**SERVICE BULLETIN**

SB No. 128 Issue No. 1

TITLE INSPECTION OF PLACARD READING "THIS AIRCRAFT IS CERTIFIED VFR IFR DAY OR NIGHT"

FIG 1
LOCATION OF PLACARD ALTERNATIVE POSITION

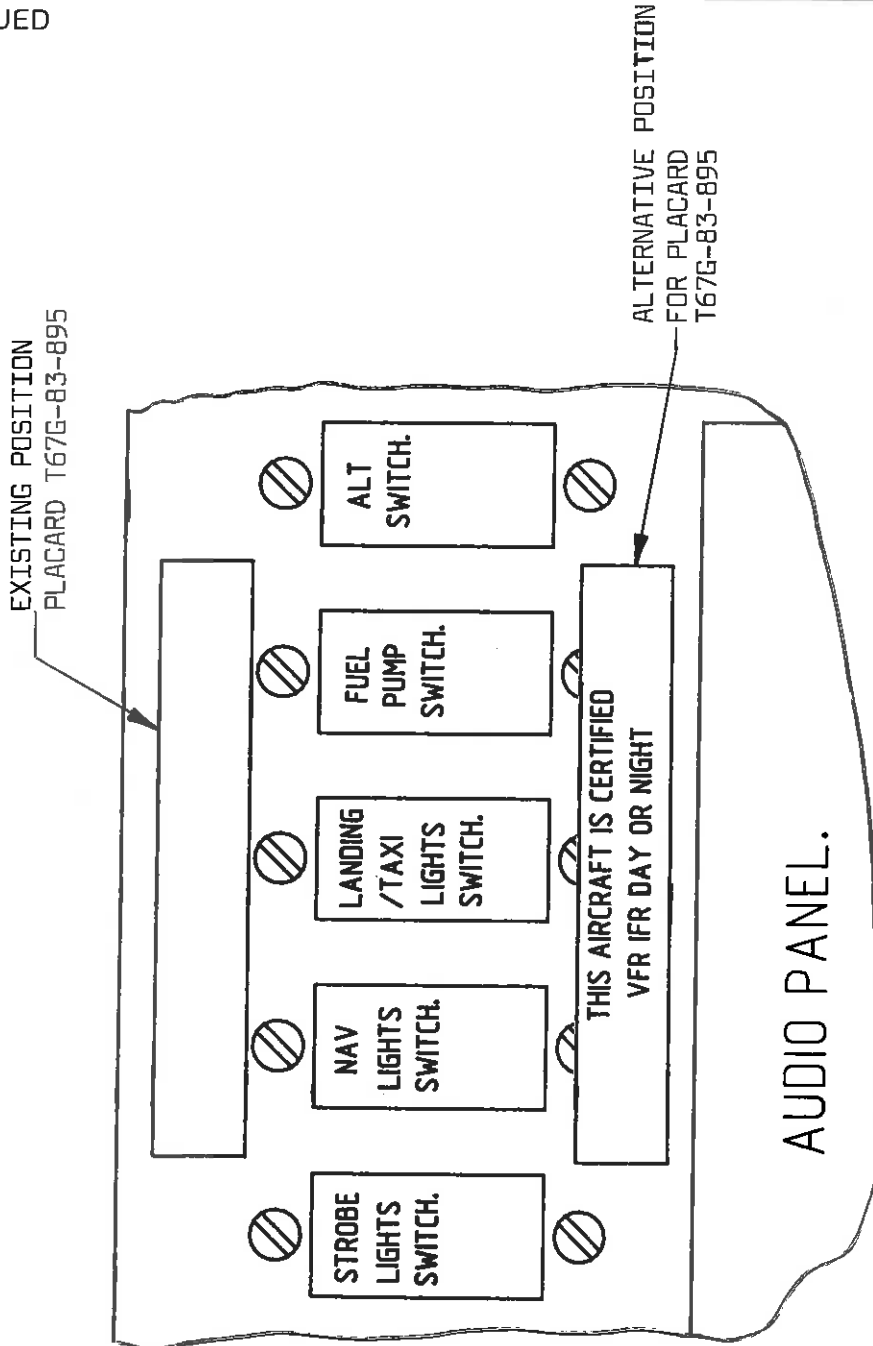
Cases have been reported of the Placard reading "This Aircraft is Certified VFR IFR Day or Night" being obscured by the glareshield.

1. Ensure placard is visible to the seated pilot/s.
2. If the placard is not visible or if there is any doubt that the placard will not be visible, then it is permissible to fit a new placard below the switches Ref. Fig. 1. Ensure panel is degreased using Spirit Wipe 126-52-067 (or approved equivalent).

Placard T67G-83-895 may be obtained from SAL Product Support Department.
